UNITED STATES PATENT AND TRADEMARK OFFICE

APPLICATION NO.	FILING DATE	FIRST NAMED INVENTOR	ATTORNEY DOCKET NO.	CONFIRMATION NO.
10/736,709	12/17/2003	Yong-Sung Ham	0630-1835P	5806

Office Action Summary	Application No. 10/736,709	Applicant(s) HAM, YONG-SUNG	
	Examiner DABORAH CHACKO DAVIS	Art Unit 1795

DETAILED ACTION

[Drawing 2] It is a mimetic diagram showing the manufacturing method of the light shielding layer by intaglio offset printing.

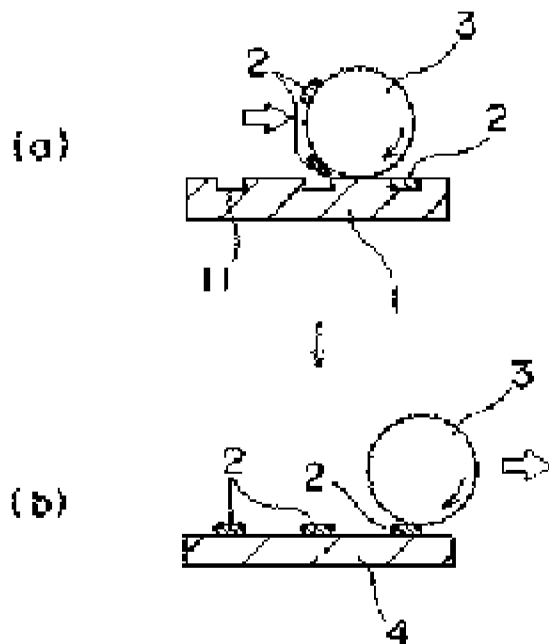
etching object layer via the blanket applied on the printing roll, wherein the area of the resist in the grooves and the area of resist transferred to the etching object layer correspond to each other. Evans, in col 10, lines 57-62, discloses that the transfer layer transfers the pattern to the substrate wherein the circumference of the transfer layer (on a printing roll) is the same as the length of the substrate to which the pattern is transferred. Evans is already relied upon to disclose the transferring of the ink pattern (ink in the grooves of the cliché) to the surface of the printing roll, which is then applied onto the surface of the etching object layer. Kondo teaches that the printing process manufactures a liquid crystal color filter for an LCD. Kondo, in [0020], teaches that the intaglio (the claimed cliché has a pattern formed in a lattice like pattern and in figures 1-2, illustrates that the grooves and the areas correspond to that of the substrate, and is the same as that illustrated and taught by the instant specification. Additionally, If Kondo is making an LCD, wherein the intaglio has the same structure as that to be transferred to the glass substrate, the intaglio will have the same structure i.e., an LCD pattern, and would require the repeating of the applying and transferring process repeatedly to complete all the unit panels. Also, the pattern 2, transferred to the substrate is the same as the claimed invention of resist transferred to the etching object layer as illustrated in applicant's drawing in figure 4C. As illustrated below, the intaglio's plurality of areas correspond to the plurality of areas of the substrate,

Kondo is relied upon to disclose that the intaglio (the claimed cliché) has plurality of grooves and has plurality of areas and Kondo, also discloses that the substrate to which the resist is transferred to is also a liquid crystal color filter for an LCD, and the liquid crystal color filter corresponds to that of the intaglio i.e., the resist from the grooves in the first area or first portion of cliché is transferred to the corresponding first area of the liquid crystal color filter (etching object layer) via the printing roll, and similarly, the resist from the second area or second portion of the intaglio is transferred to the corresponding second area of the liquid crystal color filter (etching object layer),

and so on. Furthermore, Evans, teaches manufacturing an LCD on a TFT substrate. A TFT-LCD panel inherently has, and requires (in order to be a TFT-LCD) at least the following, a glass substrate, a buffer layer, a mask or light-shielding structure, a top-gate TFT structure (gate lines), a semiconductor layer, a gate conductive structure, a gate insulating structure, a black matrix pattern etc. Evans already teaches an etching object layer, and as described above, Evans, inherently has a plurality of areas both in the intaglio and the substrate, and the claimed gate lines. Kim is relied upon to disclose the TFT- LCD device, with the claimed gate lines, pixels, pixel electrodes. As described above, Evans teaches the claimed printing process, and Kondo teaches the areas of the intaglio corresponding to the areas of the substrate. Therefore the combination of Evans in view of Kondo and Kim teaches the claimed limitations.
